PCI DESIGN HANDBOOK

8TH EDITION ERRATA

PCI Design Handbook

Eighth Edition Errata

Page 5-78, Figure 5.5.5: Replace figures with the following. Changes include adding the vertical crack 2 on the top and crack numbers on the bottom figure, revising the length of the A_s on the bottom figure, and deleting the $2h$ dimension line and A_h on the section:

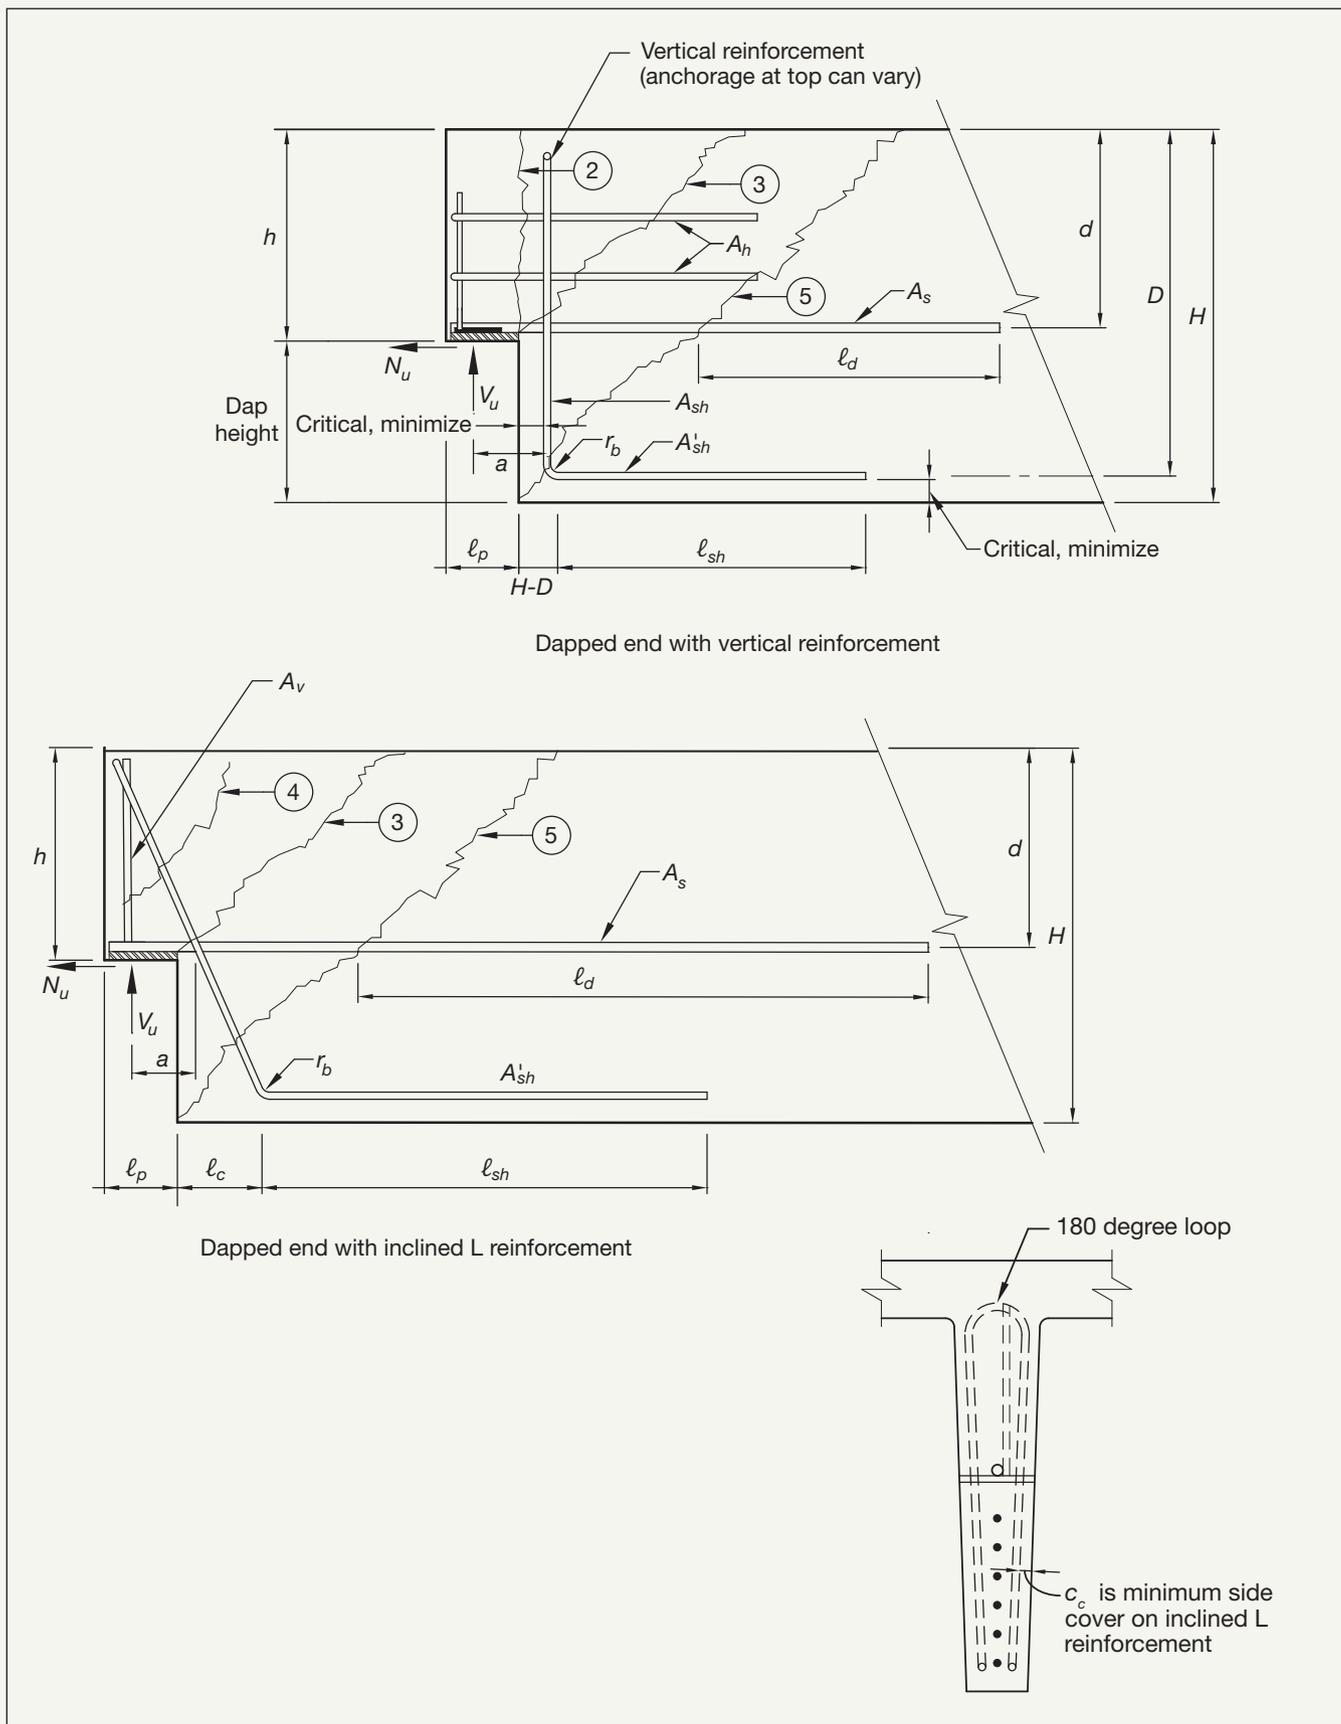
Page 5–78, Figure 5.5.5: Add the following note to figure: “Note: See Eq. 5-73, 5-74, and 5-75 for limits on the shear strength for a distance of $2H$ beyond the dap.”

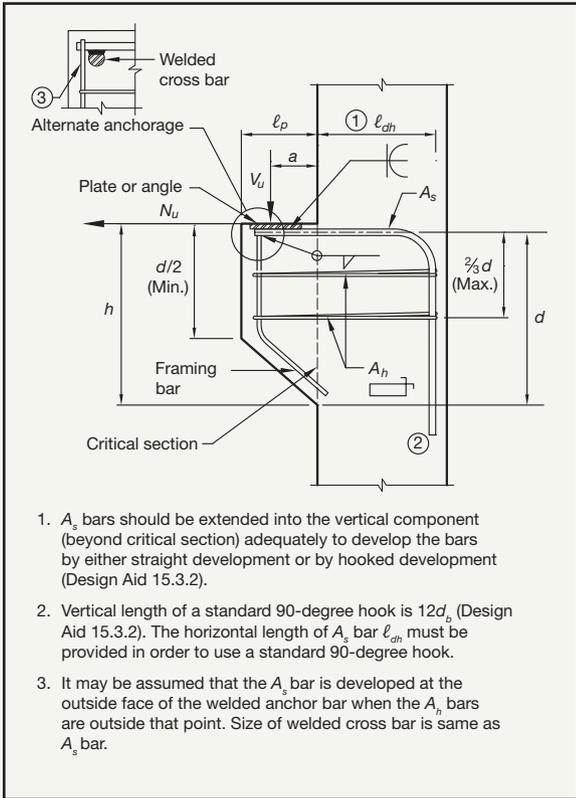
Page 5-99, Figure 5.7.1: Replace figure with the following. Change revises minimum $d/2$ dimension at face of corbel to extend from bearing surface of corbel rather than from centroid of primary reinforcement in agreement with ACI 318-14 Section 16.5.2.2 and Figure R16.5.1a. Change also revises Note 1 to replace “Design Aid 15.4.4” with “Design Aid 15.3.2”.
